Planning and Land Use Committee Report

Subject: **Development Permit with Variances Application #000293 for 1032 North Park Street**
Application to vary the required parking from fourteen stalls to five stalls to permit the construction of an eleven-unit residential building.

1032 North Park Street
Development Permit #000293

ELEVATIONS	
Project: NORTH PARK NORTH Date: JULY 11, 2013 Scale: 1/8" = 1'-0"	Sheet: A4 12854

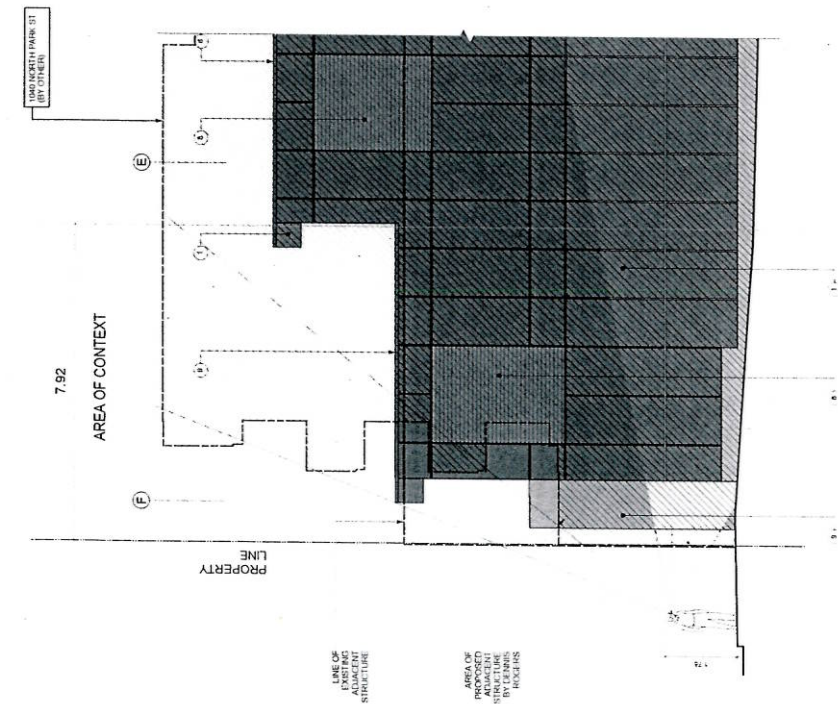
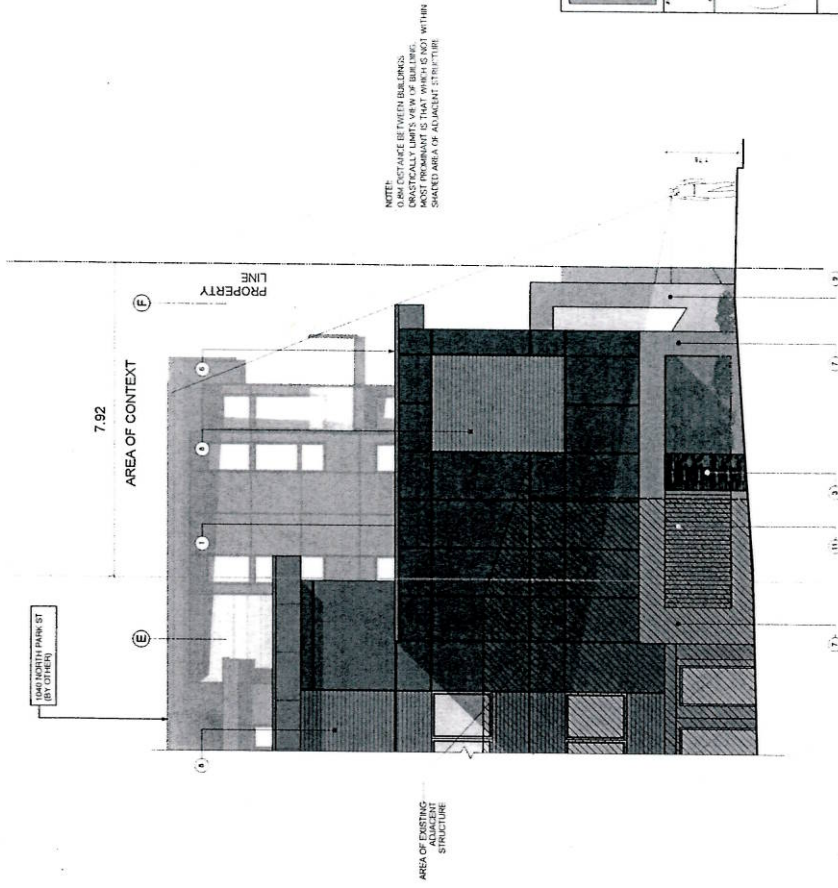
(4.3) Exposed party walls and blank side elevations, where necessary, should incorporate features such as texture, reveals, colours, plantings or other treatments to provide visual interest.

The extent to which blank side elevations may be visible will depend on the viewing point and other visual encumbrances. For example, the proposed east and west elevations contain the largest areas of blank walls; however, the extent to which these walls may be visible will depend on the massing and location of any new development that may occur to the immediate east or west of the proposed development. At the time of writing this report, the extent of blank wall that may be exposed to the east-west traffic on North Park Street would be in relation to the existing structures to the east and west of the proposed development. As depicted on drawing

The Proposed Development's East wall faces a commercial building; therefore we have proposed the blank wall to be facing the non-residential area. The West wall is articulated and provides a central, open area that will reduce the impact onto the property to the West. Fencing is proposed to be located along the property lines giving privacy to this and adjacent properties.

1 FRONT ELEVATION
Scale: 1/8" = 1'-0"

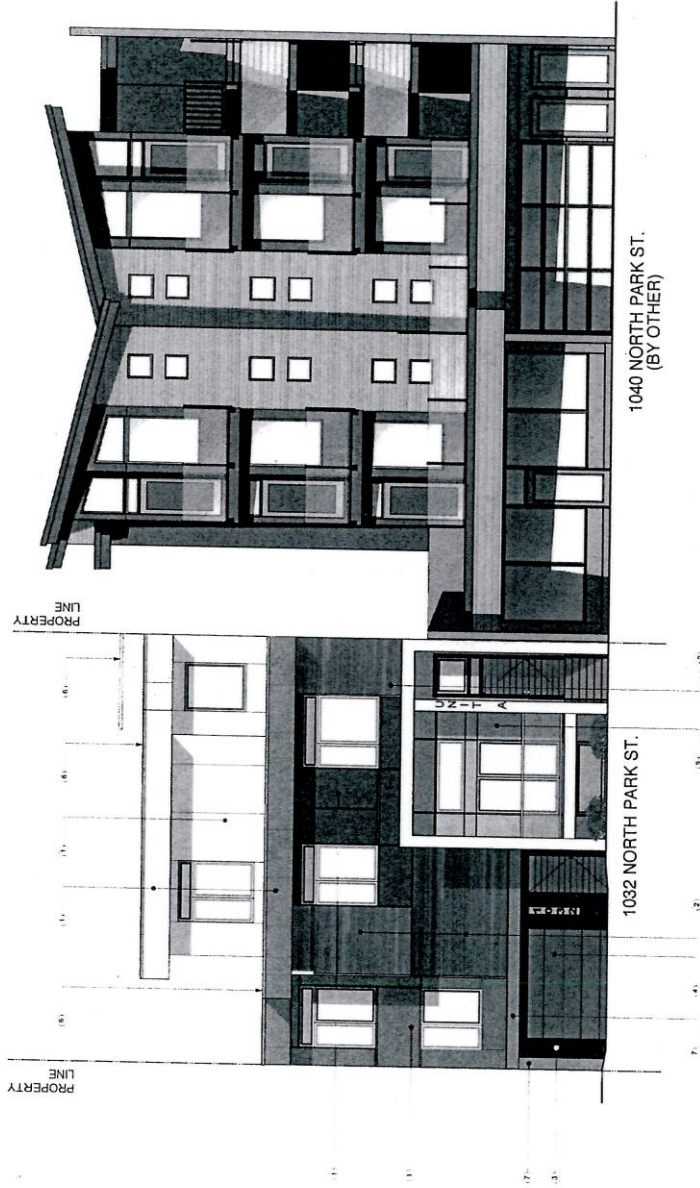
The proposed design depicts three doorways that are highly visible from North Park Street:

1. the vehicular overhead door
2. the pedestrian door to access bicycle parking and the elevator
3. the pedestrian east exit door.

There is no clear entrance to the residential units that is visible from the street, which will likely present difficulties for visitors attempting to access the building. In order to respond adequately to the Design Guidelines for Multi-Unit Residential, Commercial and Industrial Development, there is a need to strengthen the readability/identity of the primary residential entrance. It is important that the orientation and visibility of the entrance to Unit 1 be strengthened to improve the relationship between the primary residential entrance and the street.

The applicant has suggested that the proposed exit door adjacent to Unit 1 produces the same exterior appearance as if it were a main entrance door; however for users and visitors of the building, the appearance of doors on a drawing is different from how one actually identifies, uses and is guided by the clarity of entrances to the building versus an emergency exit from the building. Staff consider that the primary entrance to the building itself is unclear and that the entrance door to Unit 1 does not provide a strong or clear relationship to the street. This is because the entrance to Unit 1 does not face the street and is further concealed by the location of the exit door and associated corridor.

- (a) Revisions to the design so as to meet the *Official Community Plan*, Place Character Features objective, ensuring that the orientation of the entrance door to Unit 1 faces North Park Street and that the entrance to the building be clearly identifiable to visitors;
- (b) Plans as revised in relation to the changes noted in condition 1 (a) above;
- (c) Development meeting all Zoning Regulation Bylaw requirements, except for the following variance from Schedule C:
 - Number of parking spaces relaxed from 14 to 5
- (d) The proposed Transportation Demand Management (TDM) measures are secured by the appropriate agreement between the Victoria Car Share Cooperative and the Developer to the satisfaction of the City Solicitor; and
- (e) Final plans to be in accordance with the plans identified above to the satisfaction of the Director of Sustainable Planning and Community Development.

4710 EAST 42ND AVENUE, SUITE 100 DENVER, CO 80221 PHONE: 303.733.1111 FAX: 303.733.1112 WWW.FRAGARIAANDBOWER.COM	
PROJECT: NORTH PARK DEVELOPMENT LOCATION: 4710 EAST 42ND AVENUE, DENVER, CO 80221 DATE: JULY 11, 2013		DRAWING: A10 SCALE: 1/8" = 1'-0" SHEET: 12854	
STREETScape

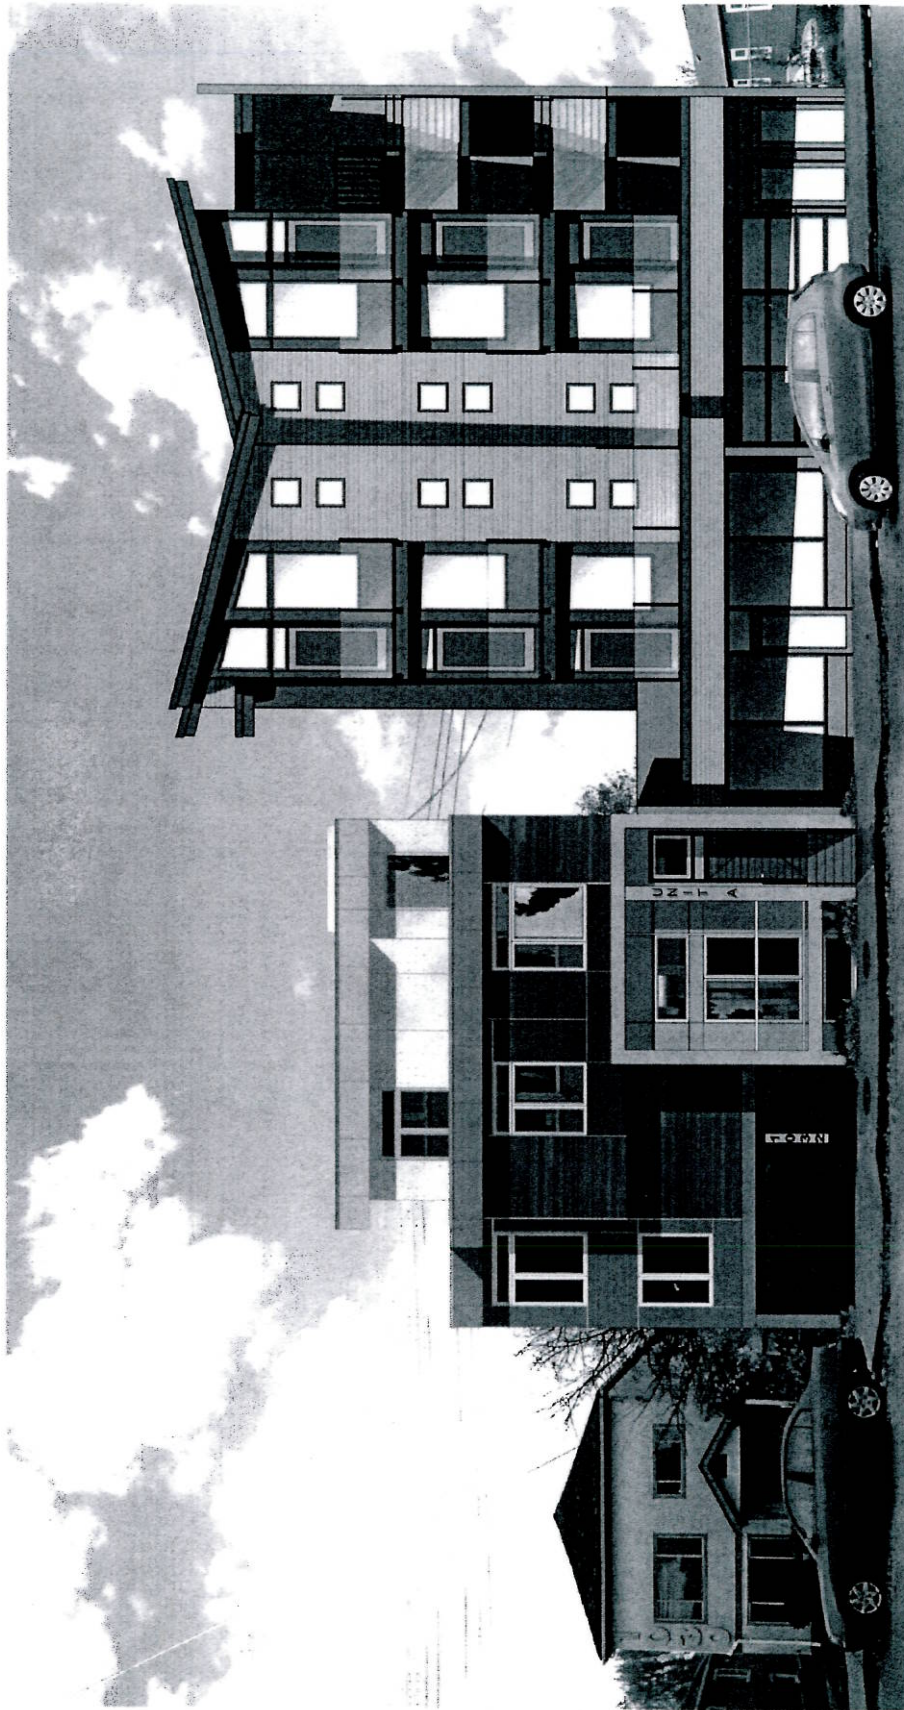
number A3, it is considered that the extent of blank wall exposed to the east and west ranges of North Park Street will be mitigated by the scale, design and location of the existing structures.
